Committee of the Whole Report For the Meeting of May 26, 2022

To: Committee of the Whole **Date:** May 13, 2022
From: Karen Hoese, Director, Sustainable Planning and Community Development
Subject: Development Permit with Variances Application No. 00051 for 937 View Street

That Council decline Development Permit with Variances Application No. 00051 for the property located at 937 View Street.

6 Shadow Study - Summer Solstice - 4PM
A105 SCALE: 1 : 1000

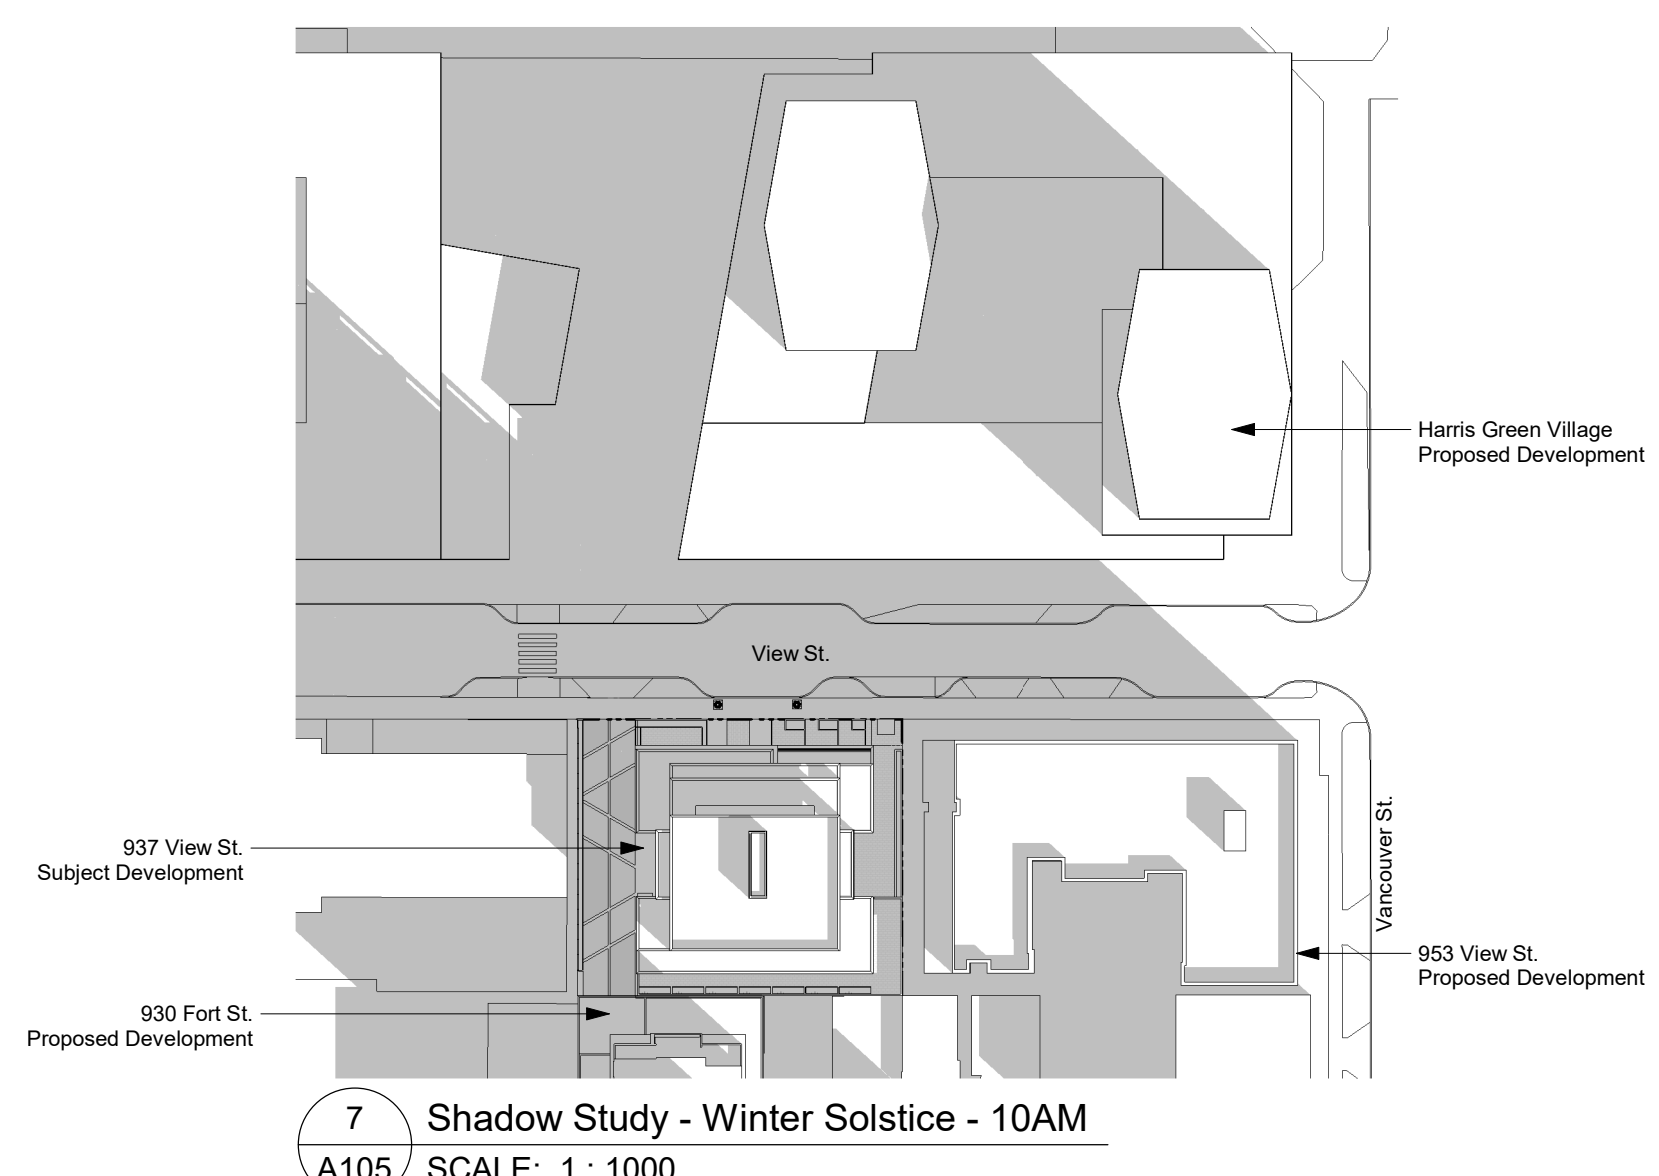
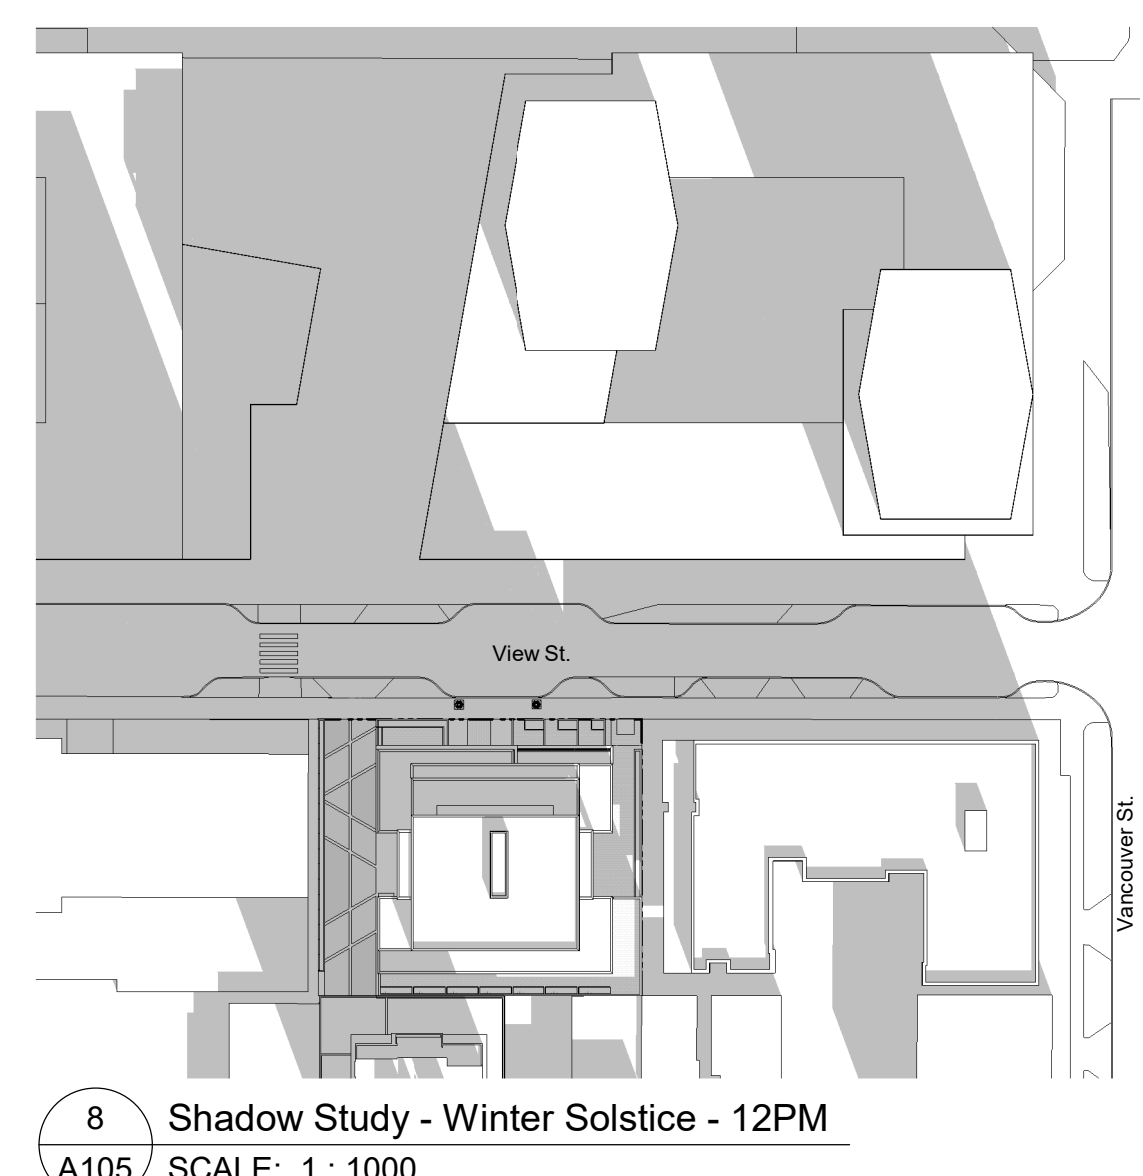
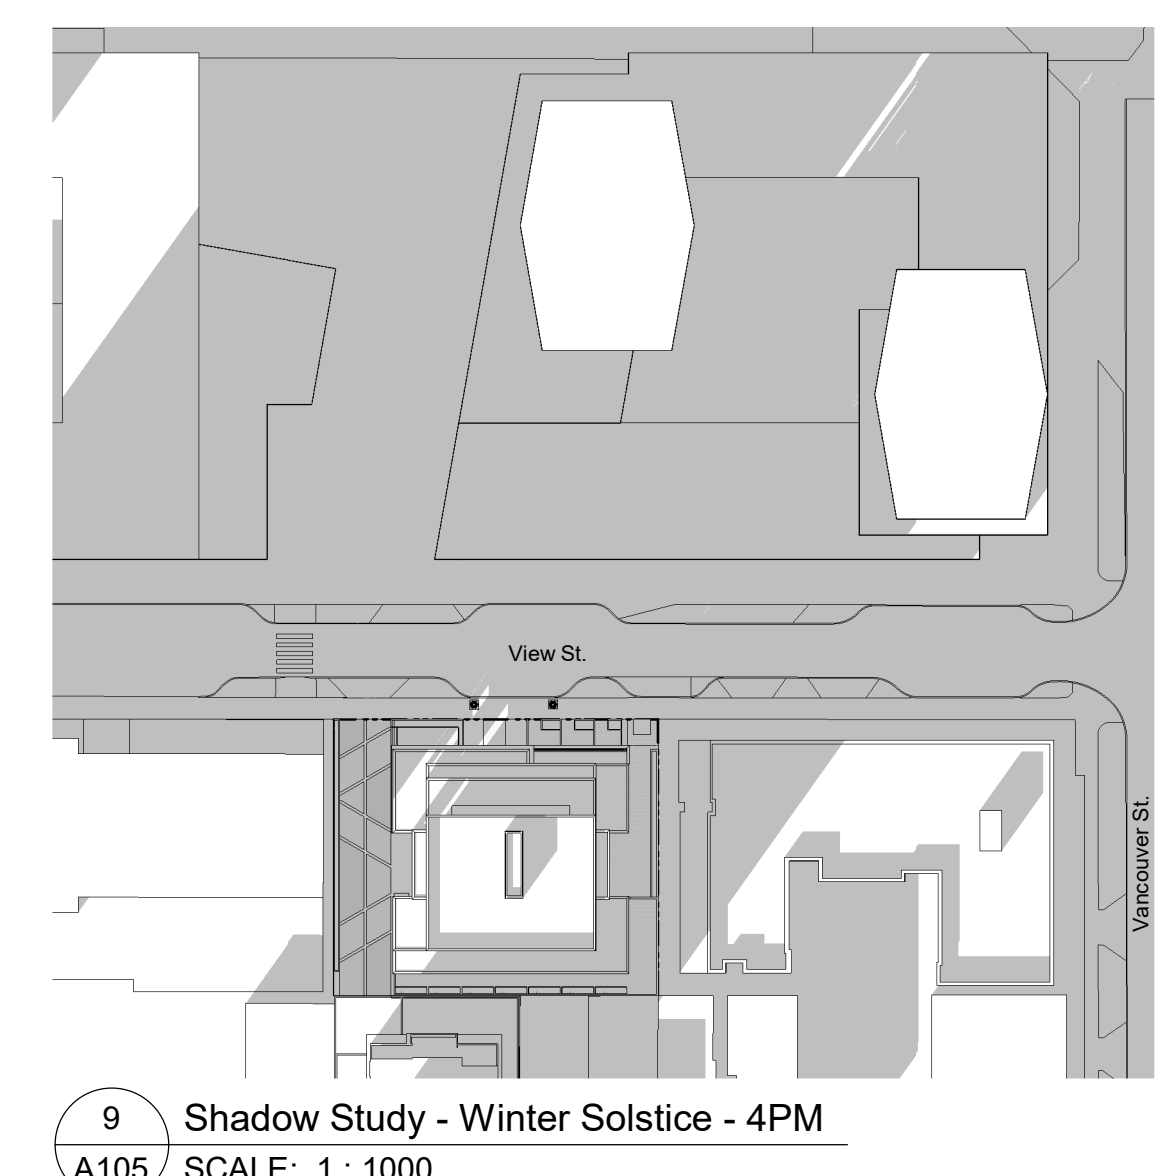
- The impact of the proposed height variance would have a detrimental impact on shading of the public realm, access to sunlight and views to the open sky, and the location directly adjacent to an existing tall building would exacerbate these negative impacts.

Policy: 8m rear setback
(2022 DCAP)

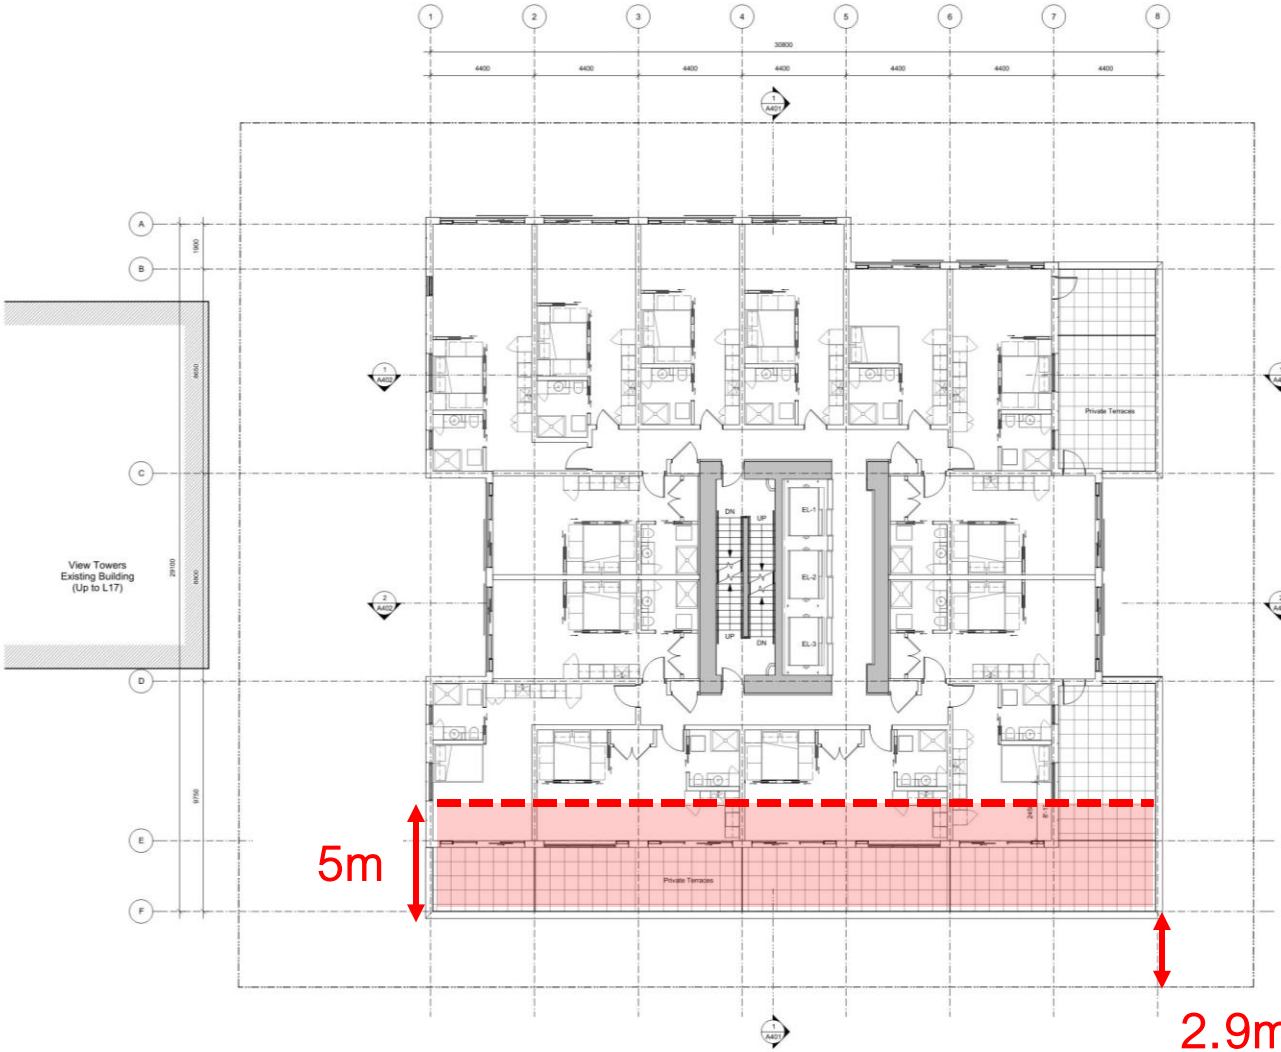
Level 10-11

5m

Policy: 10m side and rear setback (2022 DCAP)

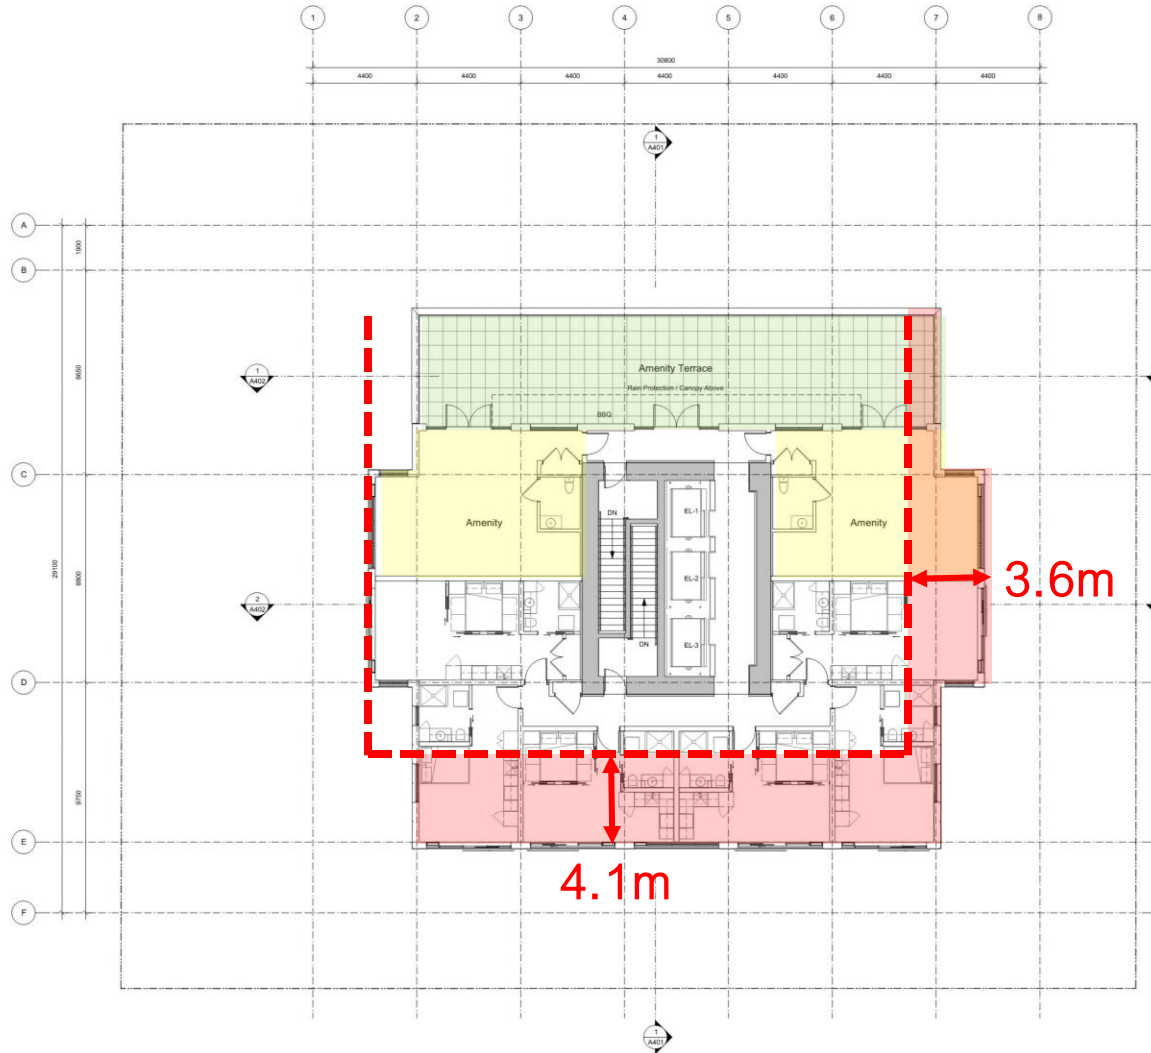
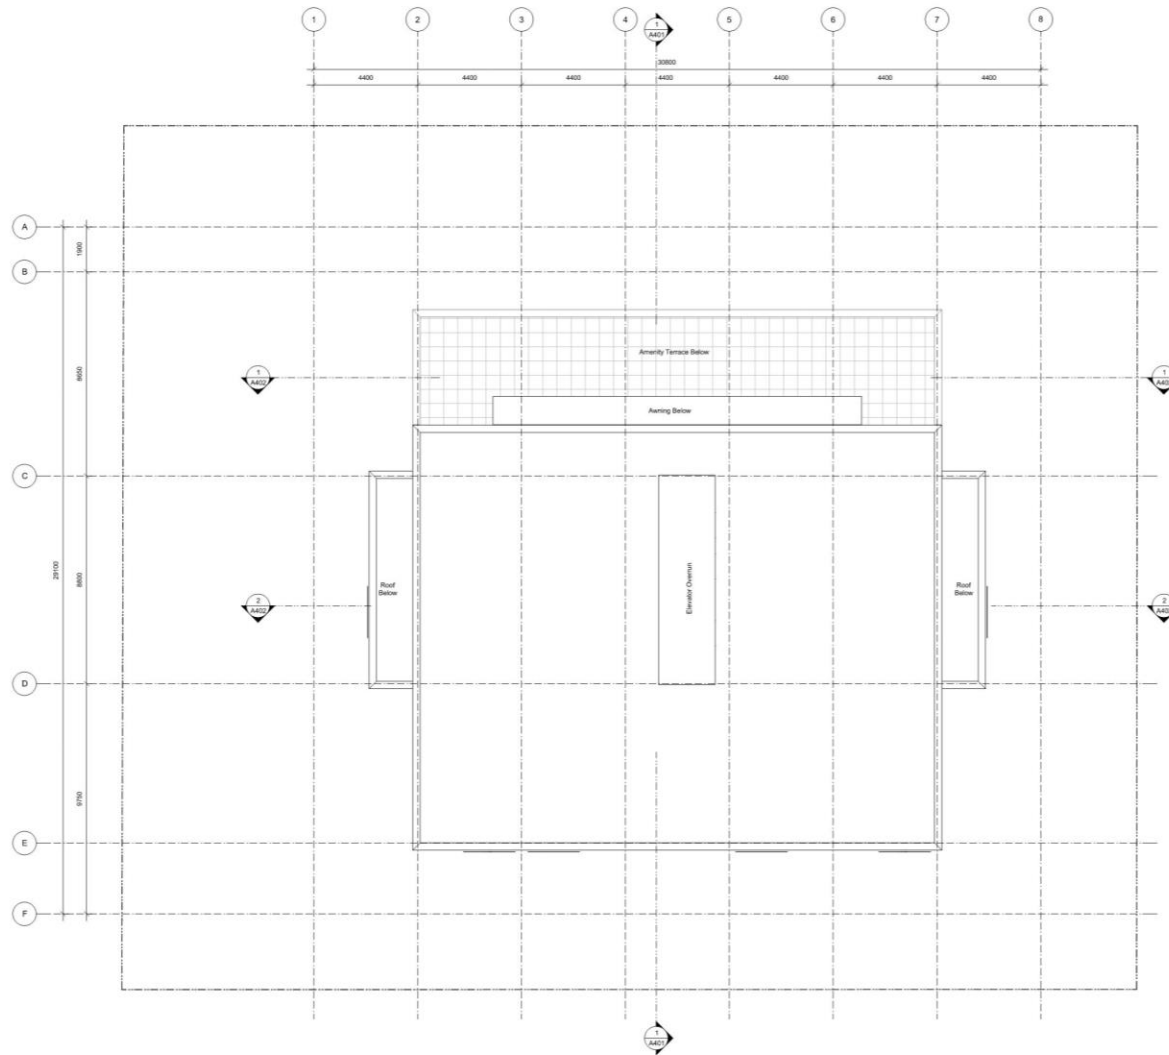
6.4m east side setback

3.6m

1.6m
